Public Safety & Transportation Committee Agenda

#239-22 **Approval of a 25% design for the Commonwealth Avenue Carriageway Redesign**
HER HONOR THE MAYOR requesting the approval of a 25% design for the Commonwealth Avenue Carriageway Redesign Project in Auburndale. The Council needs to select one of two alternatives for the Ash street intersection portion of this state-funded project.

#243-22 **Discussion regarding MassDOT's intersection project**
HER HONOR THE MAYOR requesting a discussion of MassDOT's proposed modification to the roundabout design located at the Grove Street intersection from the I-95 SB off-ramp and Quinobequin Road consistent with the requirements of Riverside Special Permit #27-20(2), Condition 14c.

From: Randy Hart, Principal
Matthew Duranleau, PERe: Grove Street at I-95 Southbound Ramps
Potential Intersection Treatments

Islington Road to Ash Street – Preferred Design (with Ash)

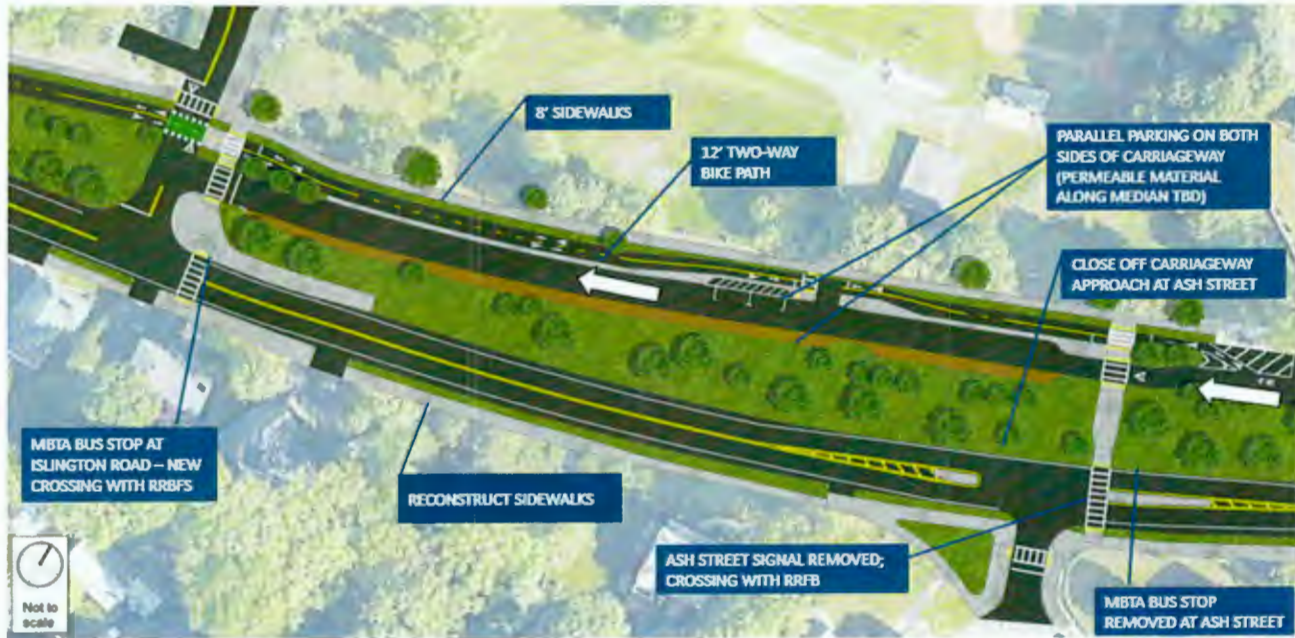
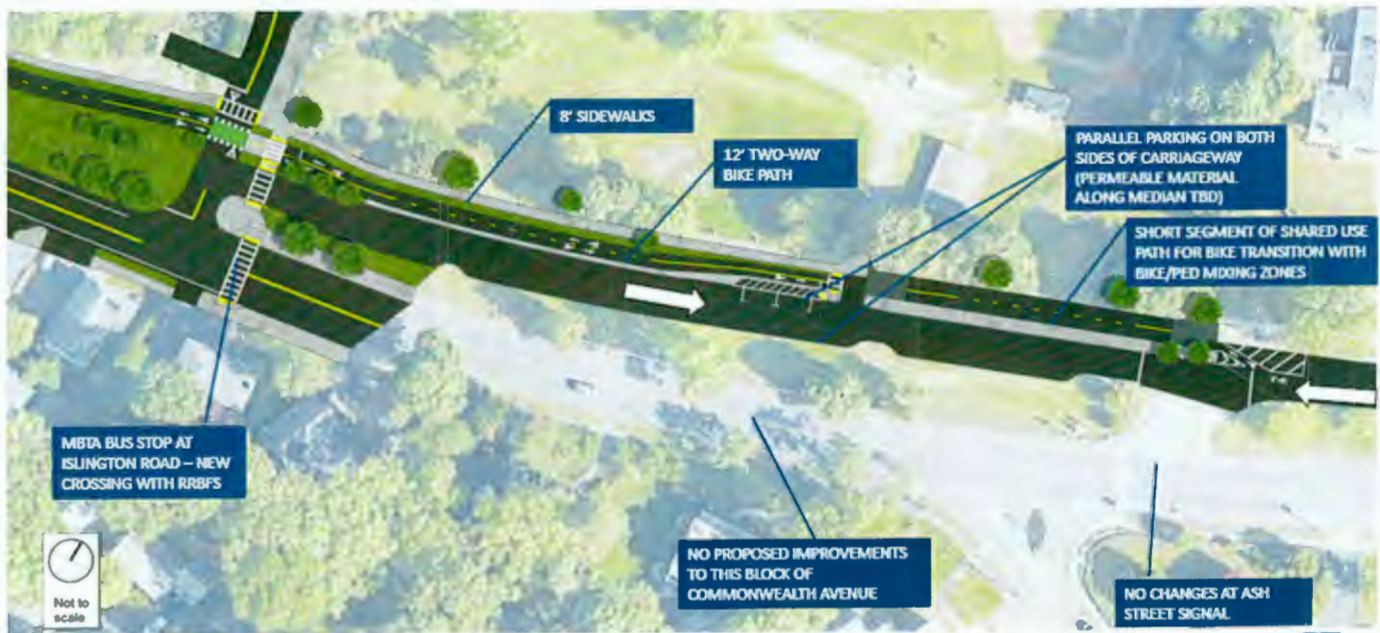
Two design alternatives exist for the segment of the project at Ash Street. MassDOT's preferred alternative reconstructs Ash Street to be fully accessible.

- There will be an accessible pedestrian crossing with an RRFB at Ash Street across Commonwealth Avenue. The existing signal will be removed.
- Traffic calming is provided on Commonwealth Avenue to slow speeds at Ash Street
- More green space is added by closing the no-longer-needed exist onto Commonwealth Avenue from the Carriageway.
- South side crosswalks are reconstructed
- The Ash Street intersection is tightened/squared to slow speeds and an accessible crossing is added across Ash where it currently doesn't exist.

The alternative design reduces the limits of the project to leave Ash Street untouched. This maintains the existing signal at Ash Street, at the cost of not implementing the above improvements. Many of the residents of the Islington Peninsula prefer this option since they exit left out of Islington onto the Carriageway to use the existing Ash Street signal head eastbound on Commonwealth Avenue.

Figure 1 Comparison of Previous and Current Roundabout Concepts

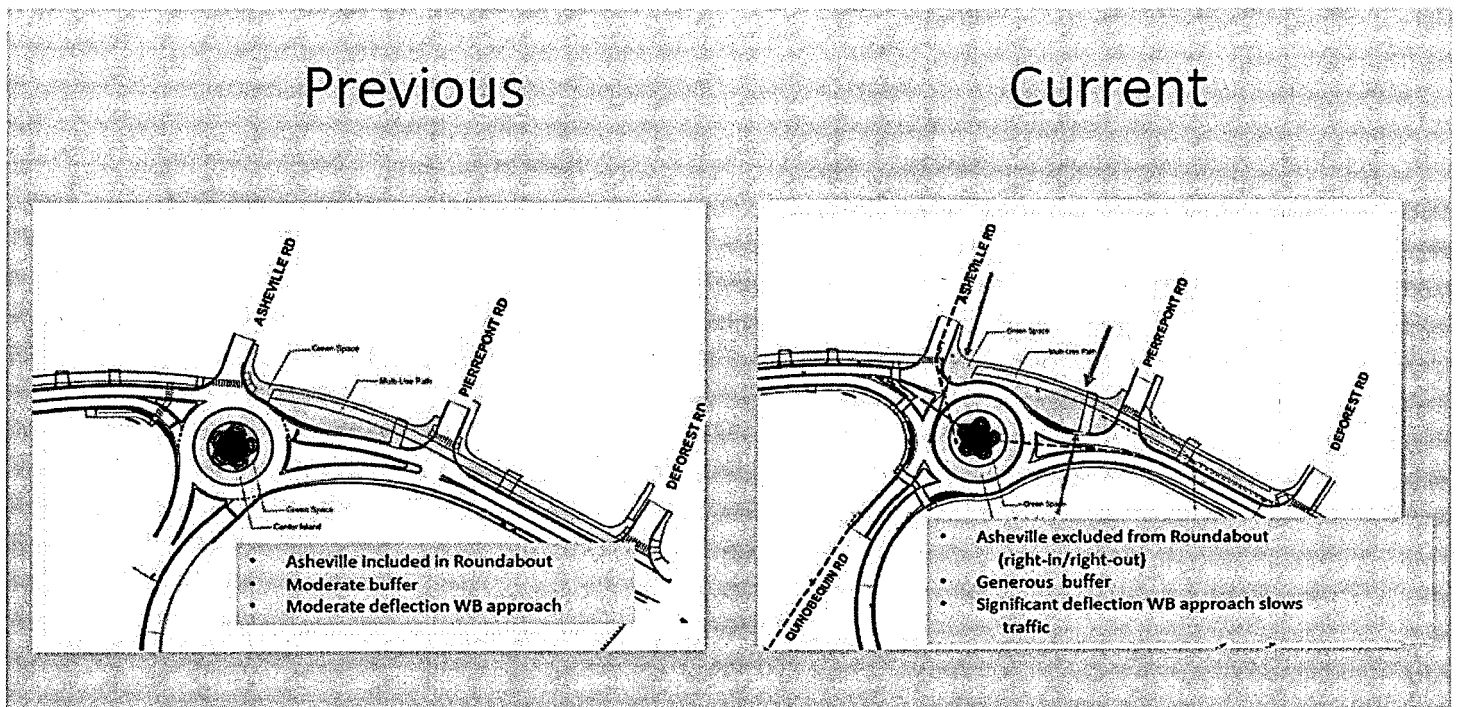
To meet the requests of MassDOT, the roundabout has been shifted a short distance to the northeast and by doing so, the geometry and right-of-way doesn't allow for Asheville Road to be included in the roundabout. Under this scenario, Asheville Road becomes a right-in/right-out at Grove Street south of the roundabout and drivers exiting Asheville Road would only be able to take a right turn onto Grove Street. To access Grove Street eastbound, drivers would need to use Pine Grove Avenue or Pierrepont Road to turn left onto Grove Street instead. Alternatively, drivers could use Pierrepont Road to turn right onto Grove Street and reverse direction at the roundabout. The proposed roundabout would consist of three approaches: Grove Street from the east and west and the I-95 Southbound Ramps from the south.

The shifting of the roundabout is a minor change from what was previously contemplated for the design of this intersection, and the only significant change is the shifting of the Roundabout easterly and the treatment of Asheville Road. There are benefits and disadvantages associated with this change, which include the following:

- › Increased deflection of the approaches will slow traffic even more than former concepts
- › Increased (substantially) green buffer between Grove Street and residents in northwest quadrant of intersection
- › Deemphasizes traffic movements onto Asheville Road (northern neighborhood traffic will likely not use Asheville to gain access to the roundabout)
- › Lower speed and more green space results in enhanced pedestrian environment

- › Residents on Asheville Road will not be able to turn left at Grove Street from Asheville's intersection with Grove.

To demonstrate the two roundabout options that have been considered, Figure 1 provides a side-by-side comparison of the previous four-legged roundabout concept and the currently proposed three-legged roundabout concept.
